PLANNING & COMMUNITY DEVELOPMENT DEPARTMENT
Land Use Review Division

RE: Administrative Decision for the Wahsatch Ave Transit Mix US-CO 5068 CMRS Plan
File Number: AR CM2 18-00636

Re: 444 East Costilla Street: File No. AR CM2 18-00636

Figure 2 – Approximate location of monopine on top of large retaining wall (tree height approximate but not to scale)

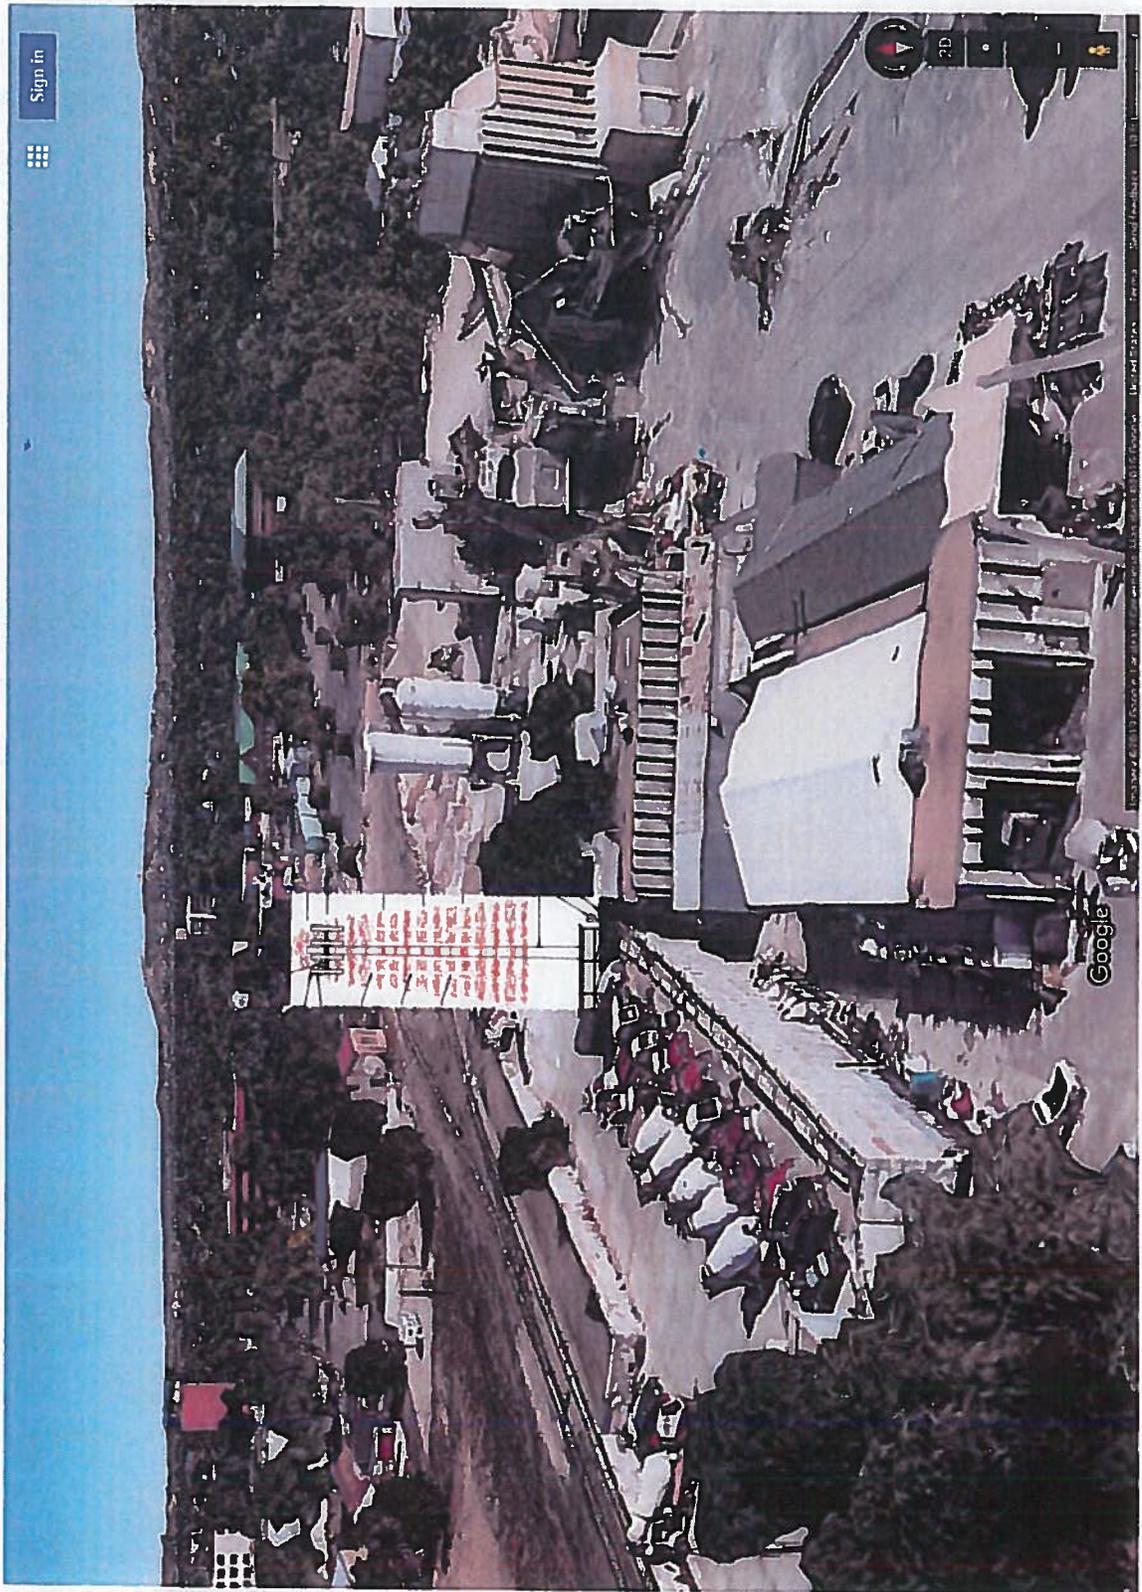
Further, City Staff finds that the proposed location does not provide the greatest screening potential. In fact, the site is located at the top of a roughly fifteen foot (15') high retaining wall which results in the facility being prominently exposed from all directions. None of the land survey sheets within the proposed plan include topographic information documenting this fact. Figure 2 is a Staff produced exhibit illustrating the proposed location of the facility using Google's publically available 3D imagery; while the proposed monopine is not to scale on the figure it represents approximate location and height relative to the surrounding area.

VIEW 1 | LOOKING WEST

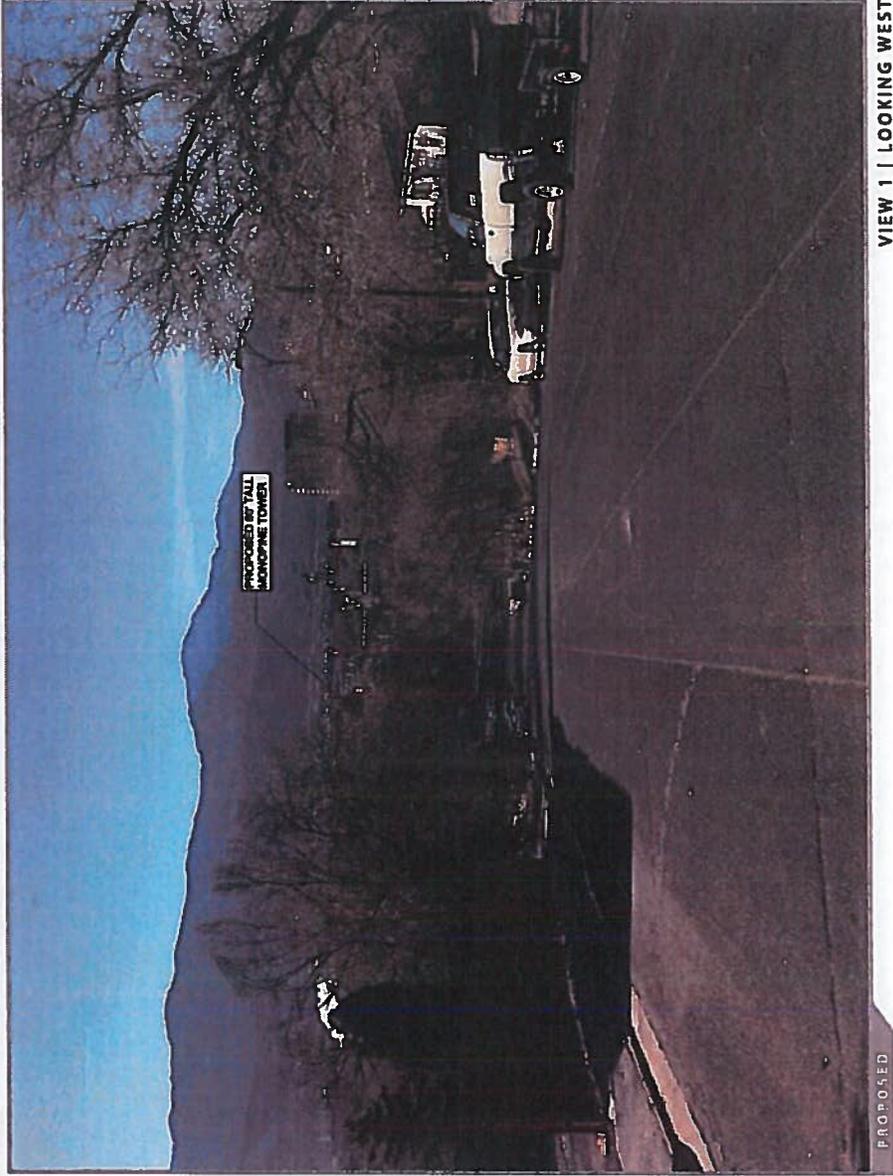
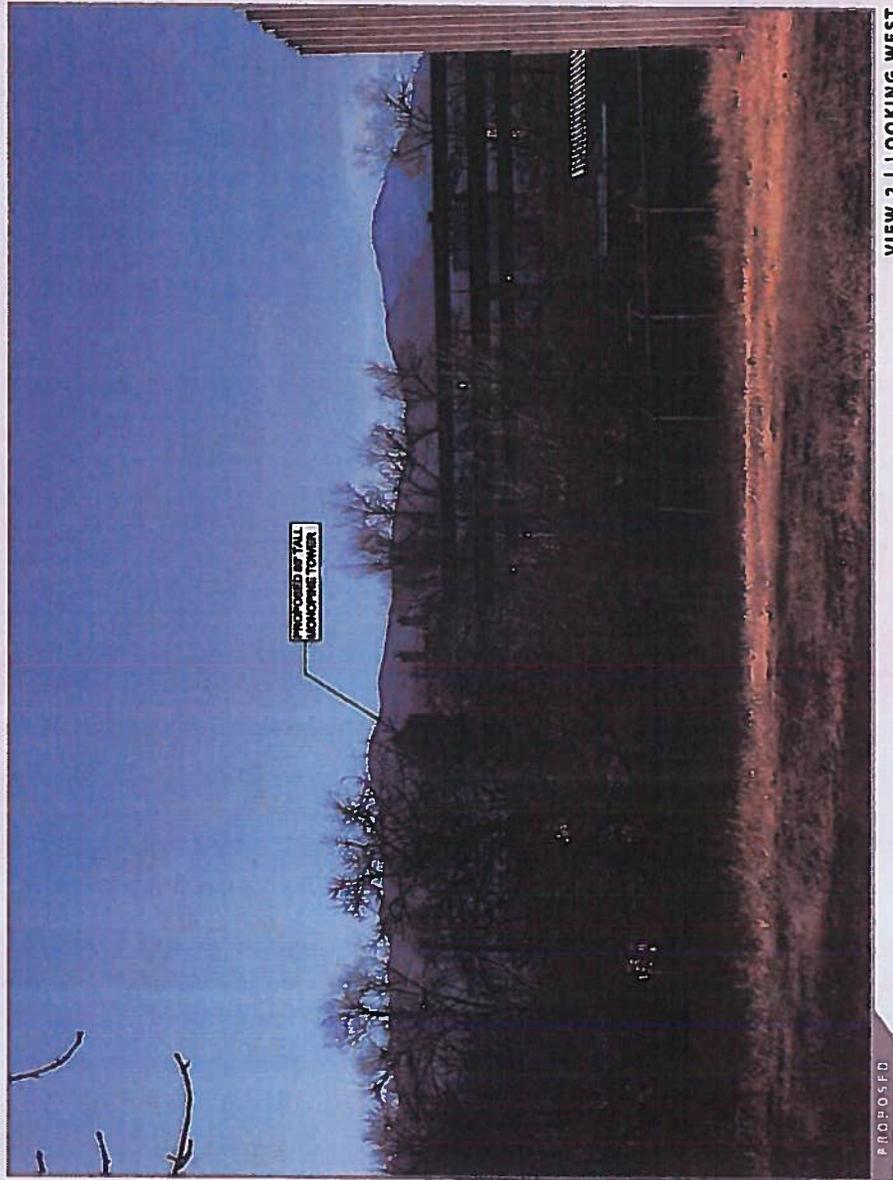
Further, the proposed mono-pine design and the location of the facility on the site are architecturally and visually incompatible with the surrounding area. Where Code requires integration, the proposed location and design are disconnected from the context of the area. The height and scale of the structure combined with the fact that it is located on the highest part of the site will create a conspicuous and glaring intrusion into the public viewsheds from both the east and the west. While Staff has emphasized the need for photo-simulations from the east looking west, Staff has consistently and repeatedly requested photo-simulations from all four directions (Figure 4 - Pre-application Notes dated 7/11/18 and Figure 5 - Review Letter dated October 9, 2018). Only photo-simulations looking west were ever provided.
